MP #25/2 Maple Springs Barn
Prelim. Consult (side addition)

HISTORIC PRESERVATION COMMISSION STAFF REPORT

Case Number: 25/2-99A REVISION #2 Staff: Robin Ziek

PROPOSAL: Add new HVAC connection between barn and Milkhouse

RIGHTSIDE ELEVATION

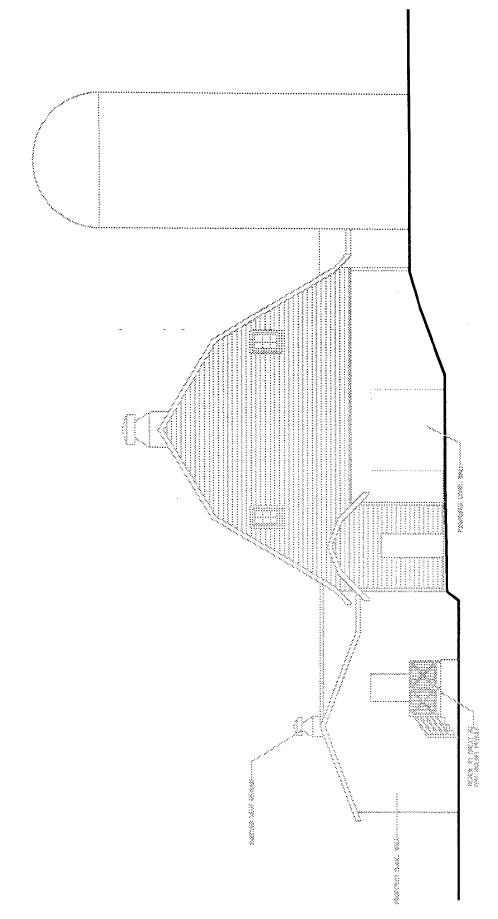
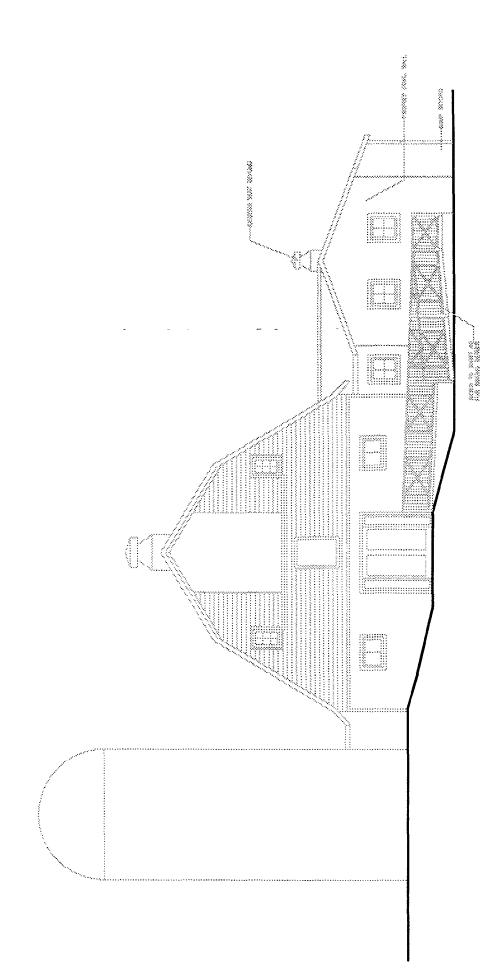
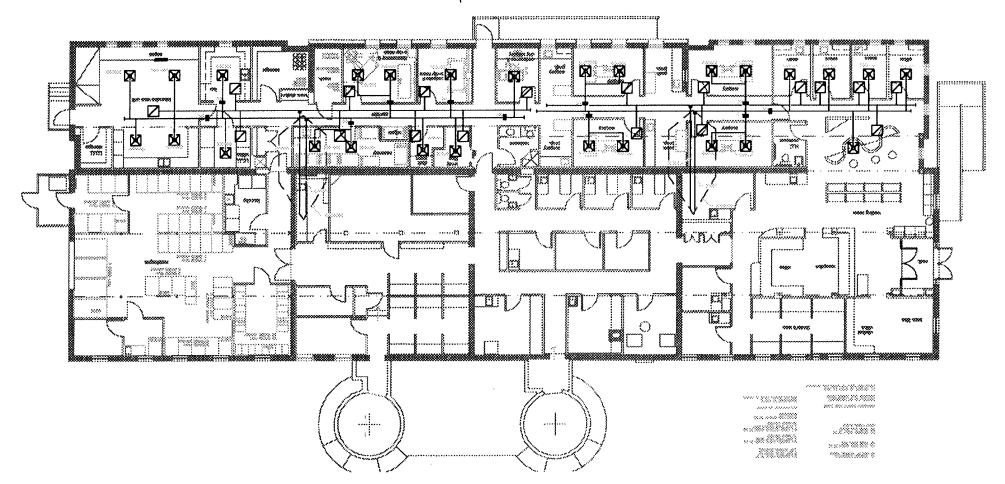
The HVAC system would include connecting ductwork from the barn to the Milkhouse which would be covered by two metal crickets in the roof (see Circle \mathcal{A}, \mathcal{V}).

This is the minimal roof alteration that is required to accommodate the HVAC ducts. Due to the differential in the roof heights between the two historic elements, and the low roof height of the Milkhouse, the ductwork cannot be accommodated within the existing roofline. The two metal crickets are restricted to the height and width of the ductwork, and are set far enough back from the front and rear edges of the roofs to minimize their visual impact. Staff feels that the utilitarian design strategy is the appropriate one for this site, and that these alterations will have no impact on the overall forms of the historic structures.

Staff recommends the Commission find this proposal consistent with the purposes of Chapter 24A-8(b)2:

NEW FLEVATION PROPOSED

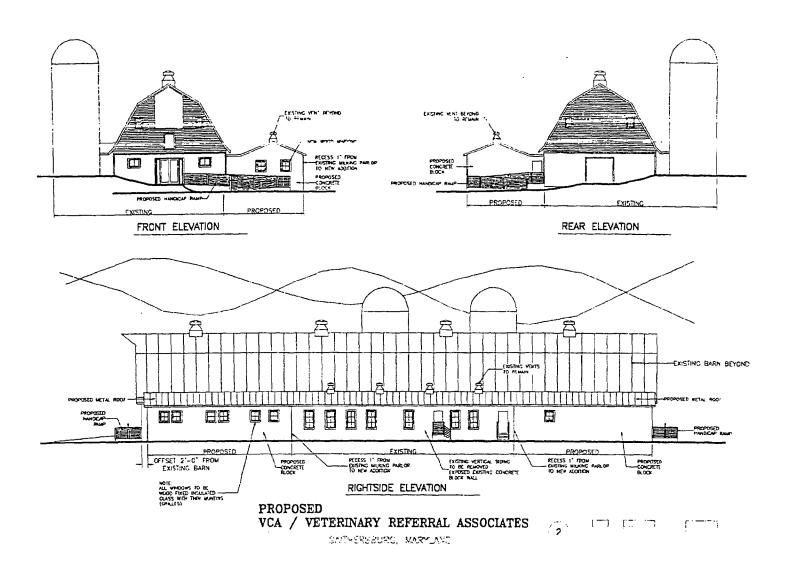
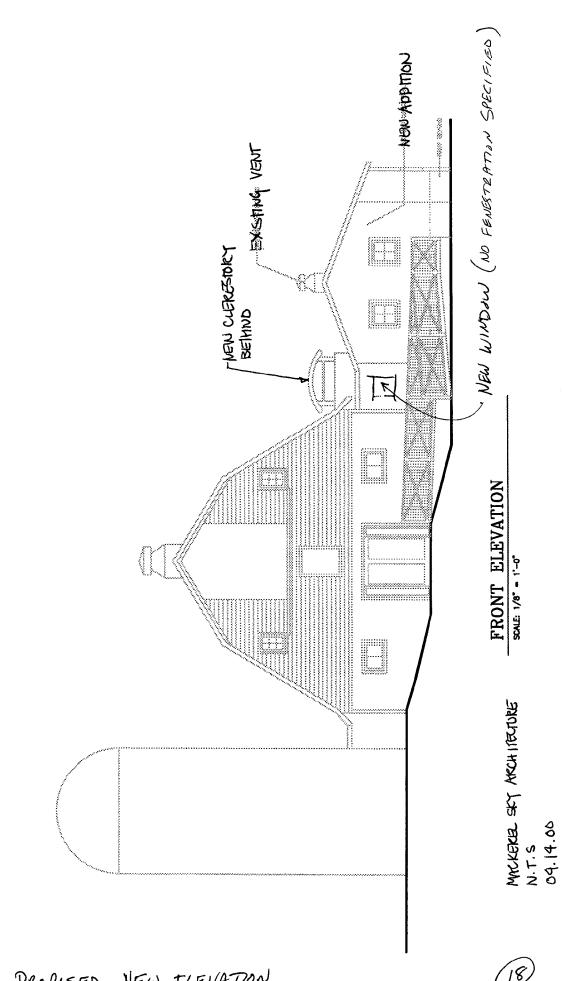
- 1. Add an additional handicapped ramp for egress from the side entrance in the milk house. This is proposed at the request of the Department of Permitting Services, in part, because of the commercial use of the property (see Circle 13).
- 2. Increase the setback of the new additions from the original front edge of the milk house from 1" to 14" (see Circle 13, 15).
- 3. Add columns "appropriate to the architecture" (see Circle) in the setback niches flanking the milk house (see Circle 15, 19).
- 4. Add additional setback and articulation at front elevation where the milk house addition joins the main part of the barn. (See Circle 14).
- 5. Replace the approved fenestration for the addition (see Circle | 2) with three small openings (see Circle | 3,14).
- 6. Add a clerestory window (see Circle 13,18) instead of the approved skylights (see Circle 2).

Item 3 is not in-keeping with the approved addition for the hospital, and is not necessary. Stylistically, the new addition was approved because it maintained the simplicity of the original structures, doing nothing to call attention to itself, and became a 'background' addition. Staff knows of no barns with exterior columns along a solid wall.

Item 6 is not in-keeping with the architecture of the barns, especially to the degree that it adds an additional element at the roof where the original ventilators dominate. Part of the simplicity of the addition was that there were no new roof elements to contrast with the original ventilators. Formally, the historic site is characterized by the three separate building blocks with their different shapes. These three elements - the silos, barn and milkhouse - are typical of the dairy industry, and the historic designation seeks to preserve this example of the dairy industry for the county. The introduction of a new decorative design element in the roofscape is not consistent with the historic site. Furthermore, the applicant can achieve light in the waiting room with other options, including the addition of a window (which is proposed), possibly with skylights (which they originally proposed), and with interior lighting.

- 1. The applicant will delete the clerestory.
- 2. The applicant will delete the columns.

- NEW ADDITION COPPLET W CCLUMN ITY OF (B) RIGHTSIDE ELEVATION 70000000 2...;...0 2000000 3000000 2.3... 2000000 L NEW ADDITION

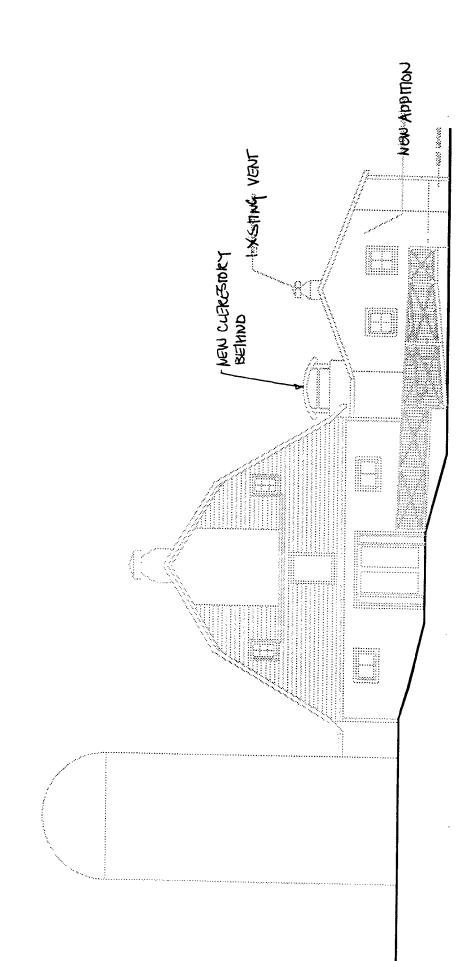
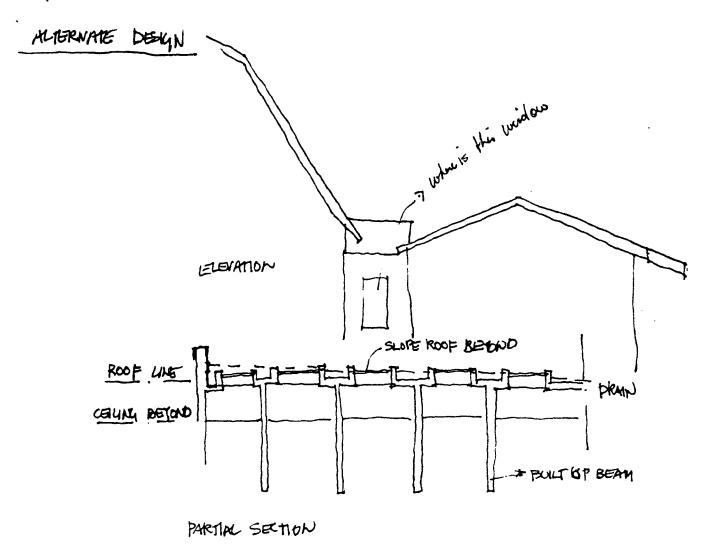
Please find attached the plan, front elevation, and the south elevation. (Right side elevation) for the above reference project. Please note the clerestory area set back from the front roof eave and fascia line. This was introduced into the project to maintain a historical reference to the open area between the barn and milking parlor that existed originally.
